PRELIMINARY DETERMINATION SUBMISSION

CENTRAL AVENUE SOLAR

1257 AND 1260 CENTRAL AVENUE

RI DEPARTMENT OF ENVIRONMENTAL MANAGEMENT
OFFICE OF WATER RESOURCES
FRESHWATER WETLANDS PROGRAM
APPROVED WITH CONDITIONS AS SPECIFIED IN THE LETTER OF APPROVAL
DATED: APR 24 2023 FILE # 22-0059
NO CHANGES ALLOWED WITHOUT PRIOR APPROVAL
APPROVED PLANS MUST BE AT CONSTRUCTION SITE

COVER SHEET
CENTRAL AVENUE SOLAR
ASSESSOR'S PLAT 43 LOTS 70 AND 95
JOHNSTON, RHODE ISLAND
PREPARED FOR:
REVITY ENERGY, LLC
117 METRO CENTER BLVD. WARWICK, RHODE ISLAND 02886

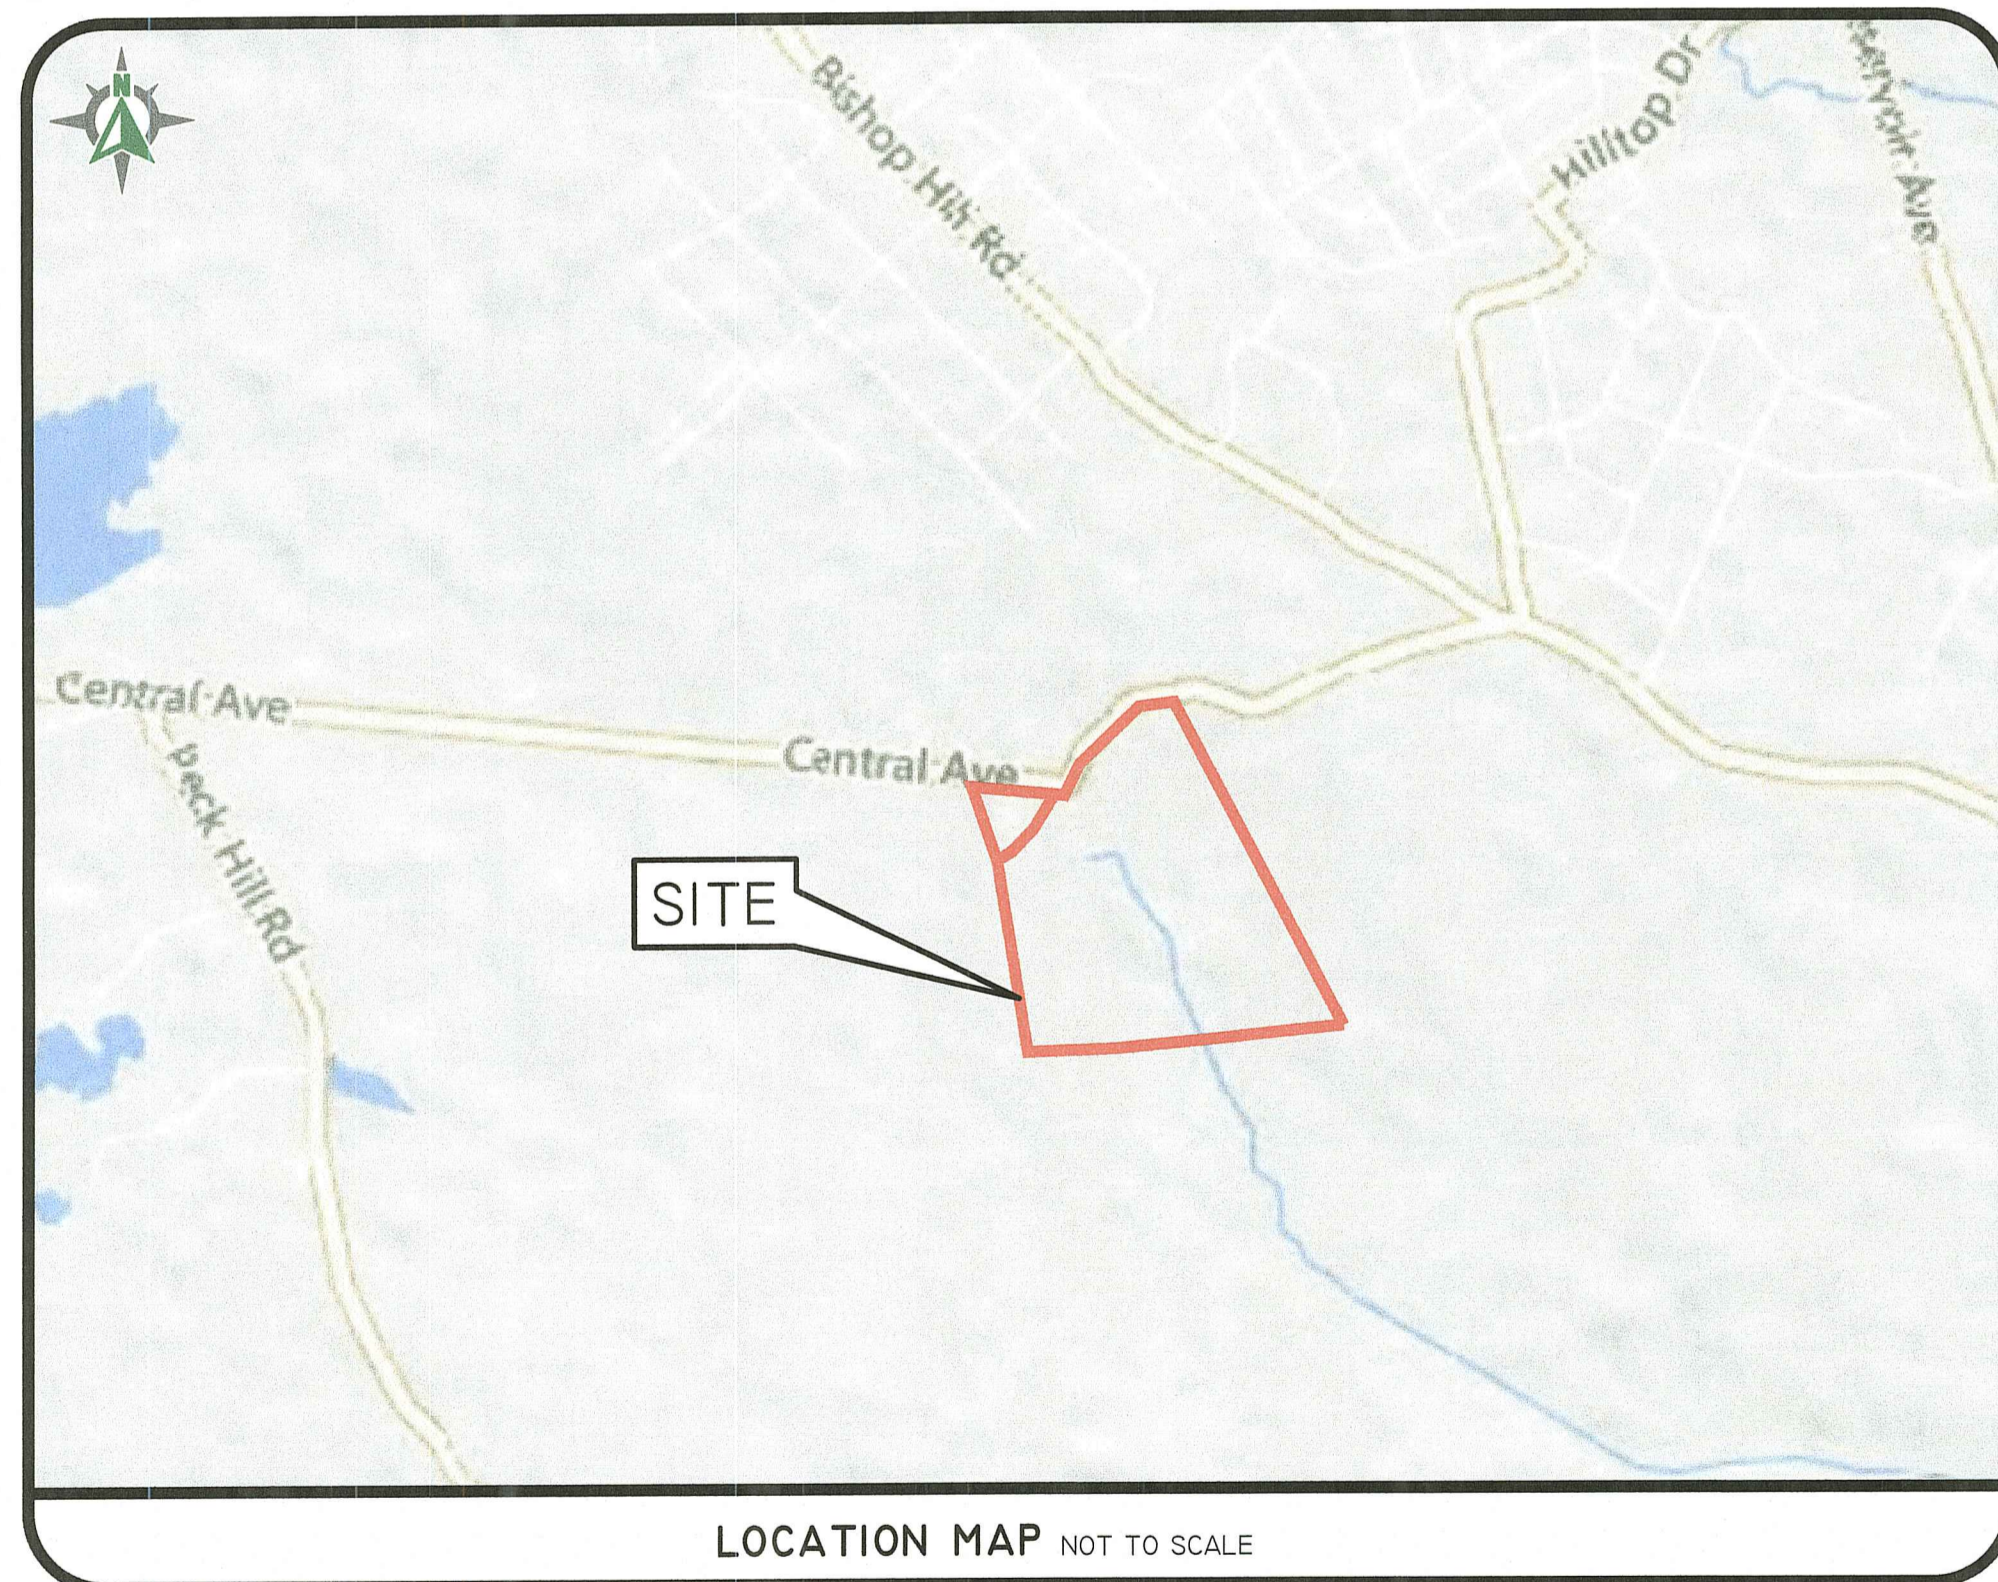
See Revised Sheet 7 of 12.

GRADING & DRAINAGE PLAN - I
 CENTRAL AVENUE SOLAR
 ASSESSOR'S PLAT 43 LOTS 70 AND 95
 JOHNSTON, RHODE ISLAND

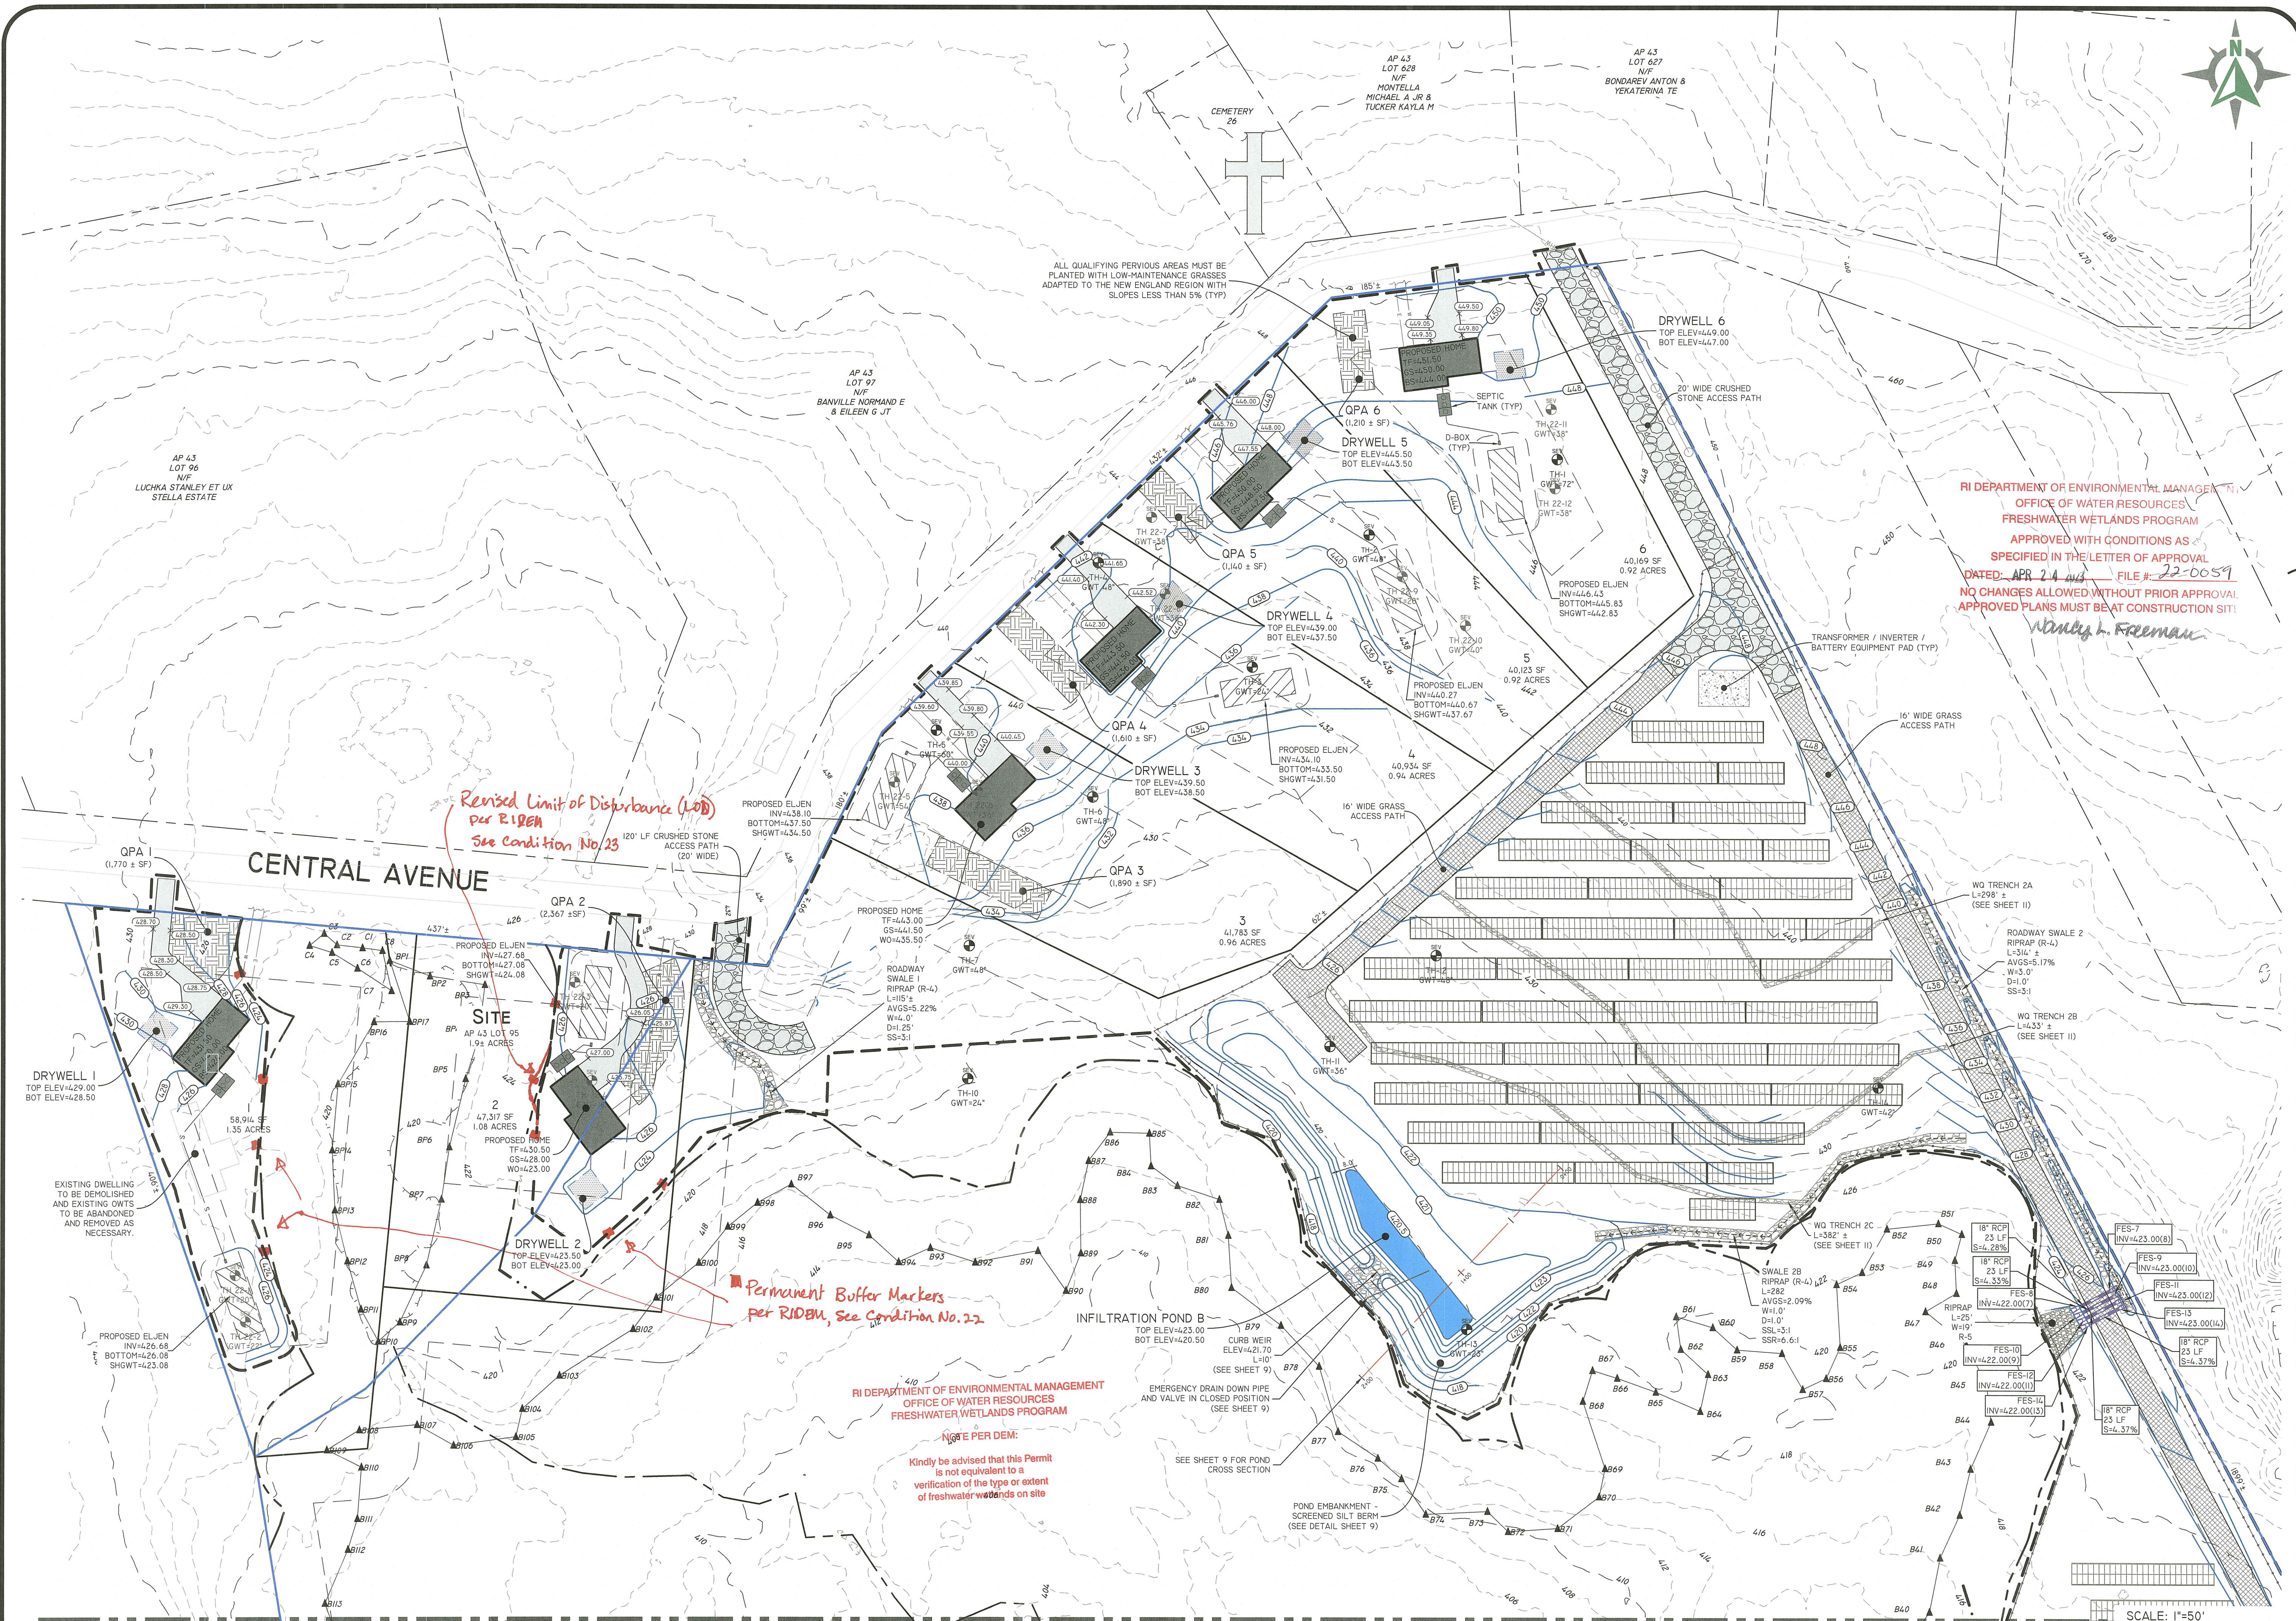
Revised Limit of Disturbance (LOD)
 per R1DEM
 See Condition No. 23

Permanent Buffer Markers
 per R1DEM, See Condition No. 23
